Check report by Sales + CR after finishing stage IV (Apartments)

Flat No	119	Other		Sl. No.	43210
Company	MRCV	Project		Phase	
Prepared by	Venkatesh Reddy	Sign		Date	5/11/24
Project Manager	Sarwan	Sign		Date	5-11-2024
Stage II report no.					
Checked By MD on		MD Sign		For filling	☐ Yes ☐ No
Recommendation: ☒ Work is satisfactorily completed. Possession may be handed over. ☐ Minor corrections given herein to be completed before handing over possession. ☐ Major corrections required. Do not handover possession. Request for recheck after completion of works. ☐ Works incomplete. Check report cannot be prepared. Request for recheck after completion of works.

Details of Additions & Alterations

Flat No	119	Type	Deluxe / Semi-Deluxe
Buyer Name	T. Vasudev Reddy		
Phone No.	9951799542	Email	T.V.Reddy 02 Cgm@tcm

Description	Direction	Owners & Developers :		Date	24/09/2021	Prepared By	Imran	Reviewed By	Modi Properties Pvt. Ltd
		Project Name & Phase		Approved By	Soham Akhadi	Project No: 2018/00000000000000000000			
		BRCIV		Scale	N 1 S				
Plumbing plan west facing	N

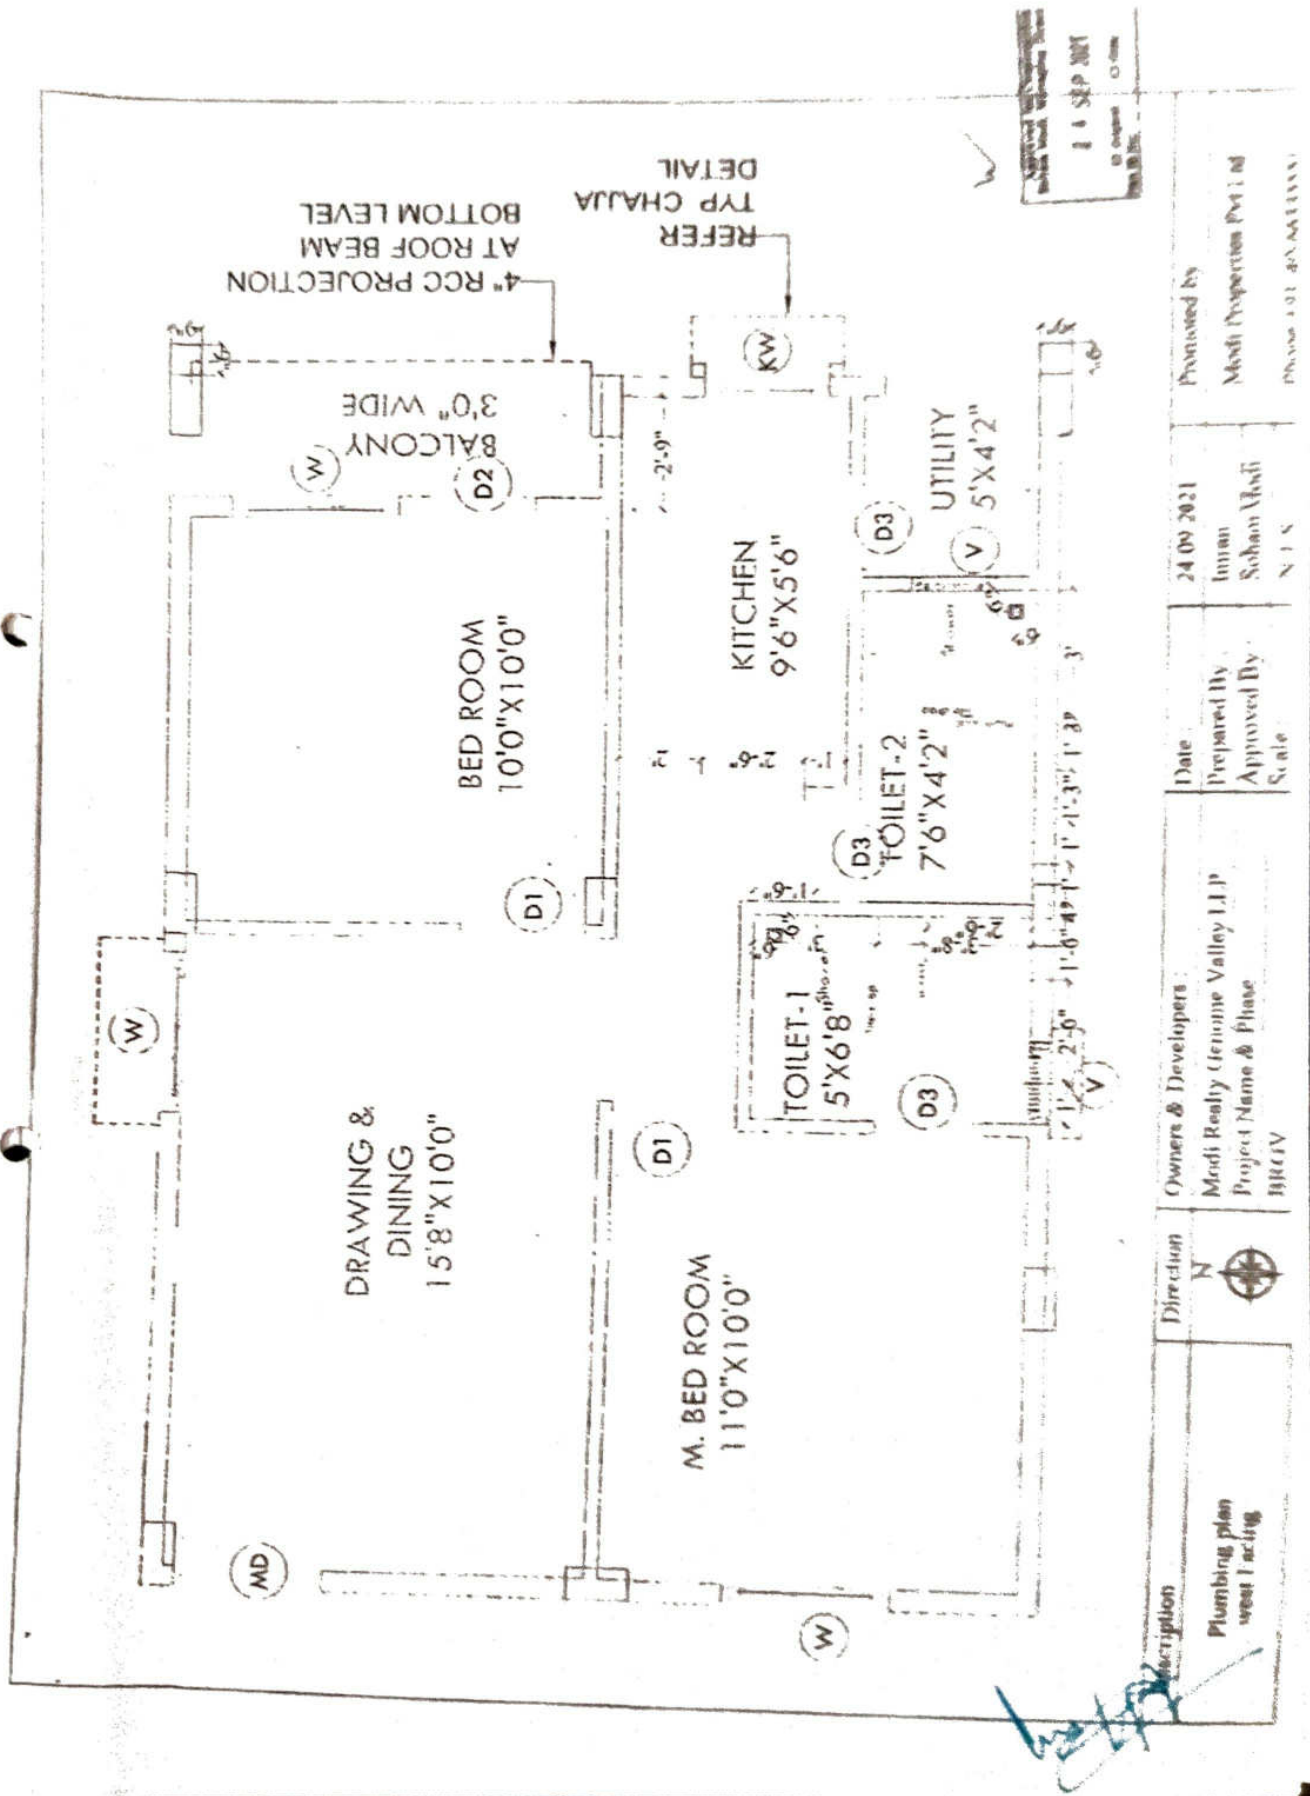
Changes in flooring:

① Harkit Tahr asphalt (2-1) Same as C. Tahr.

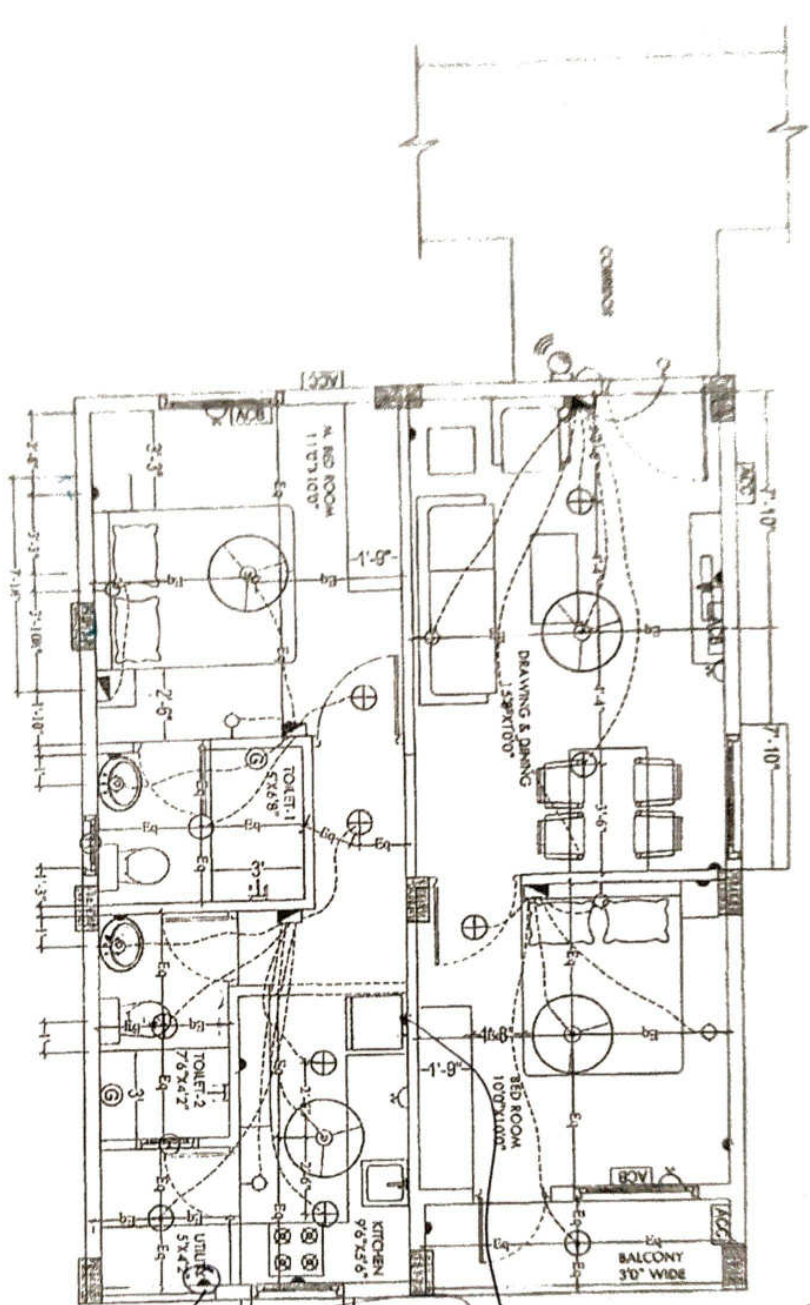
Changes in electrical points: (mark on plan)

① 16-amp outlet for fridge.

② 16-amp outlet for utility water heater.
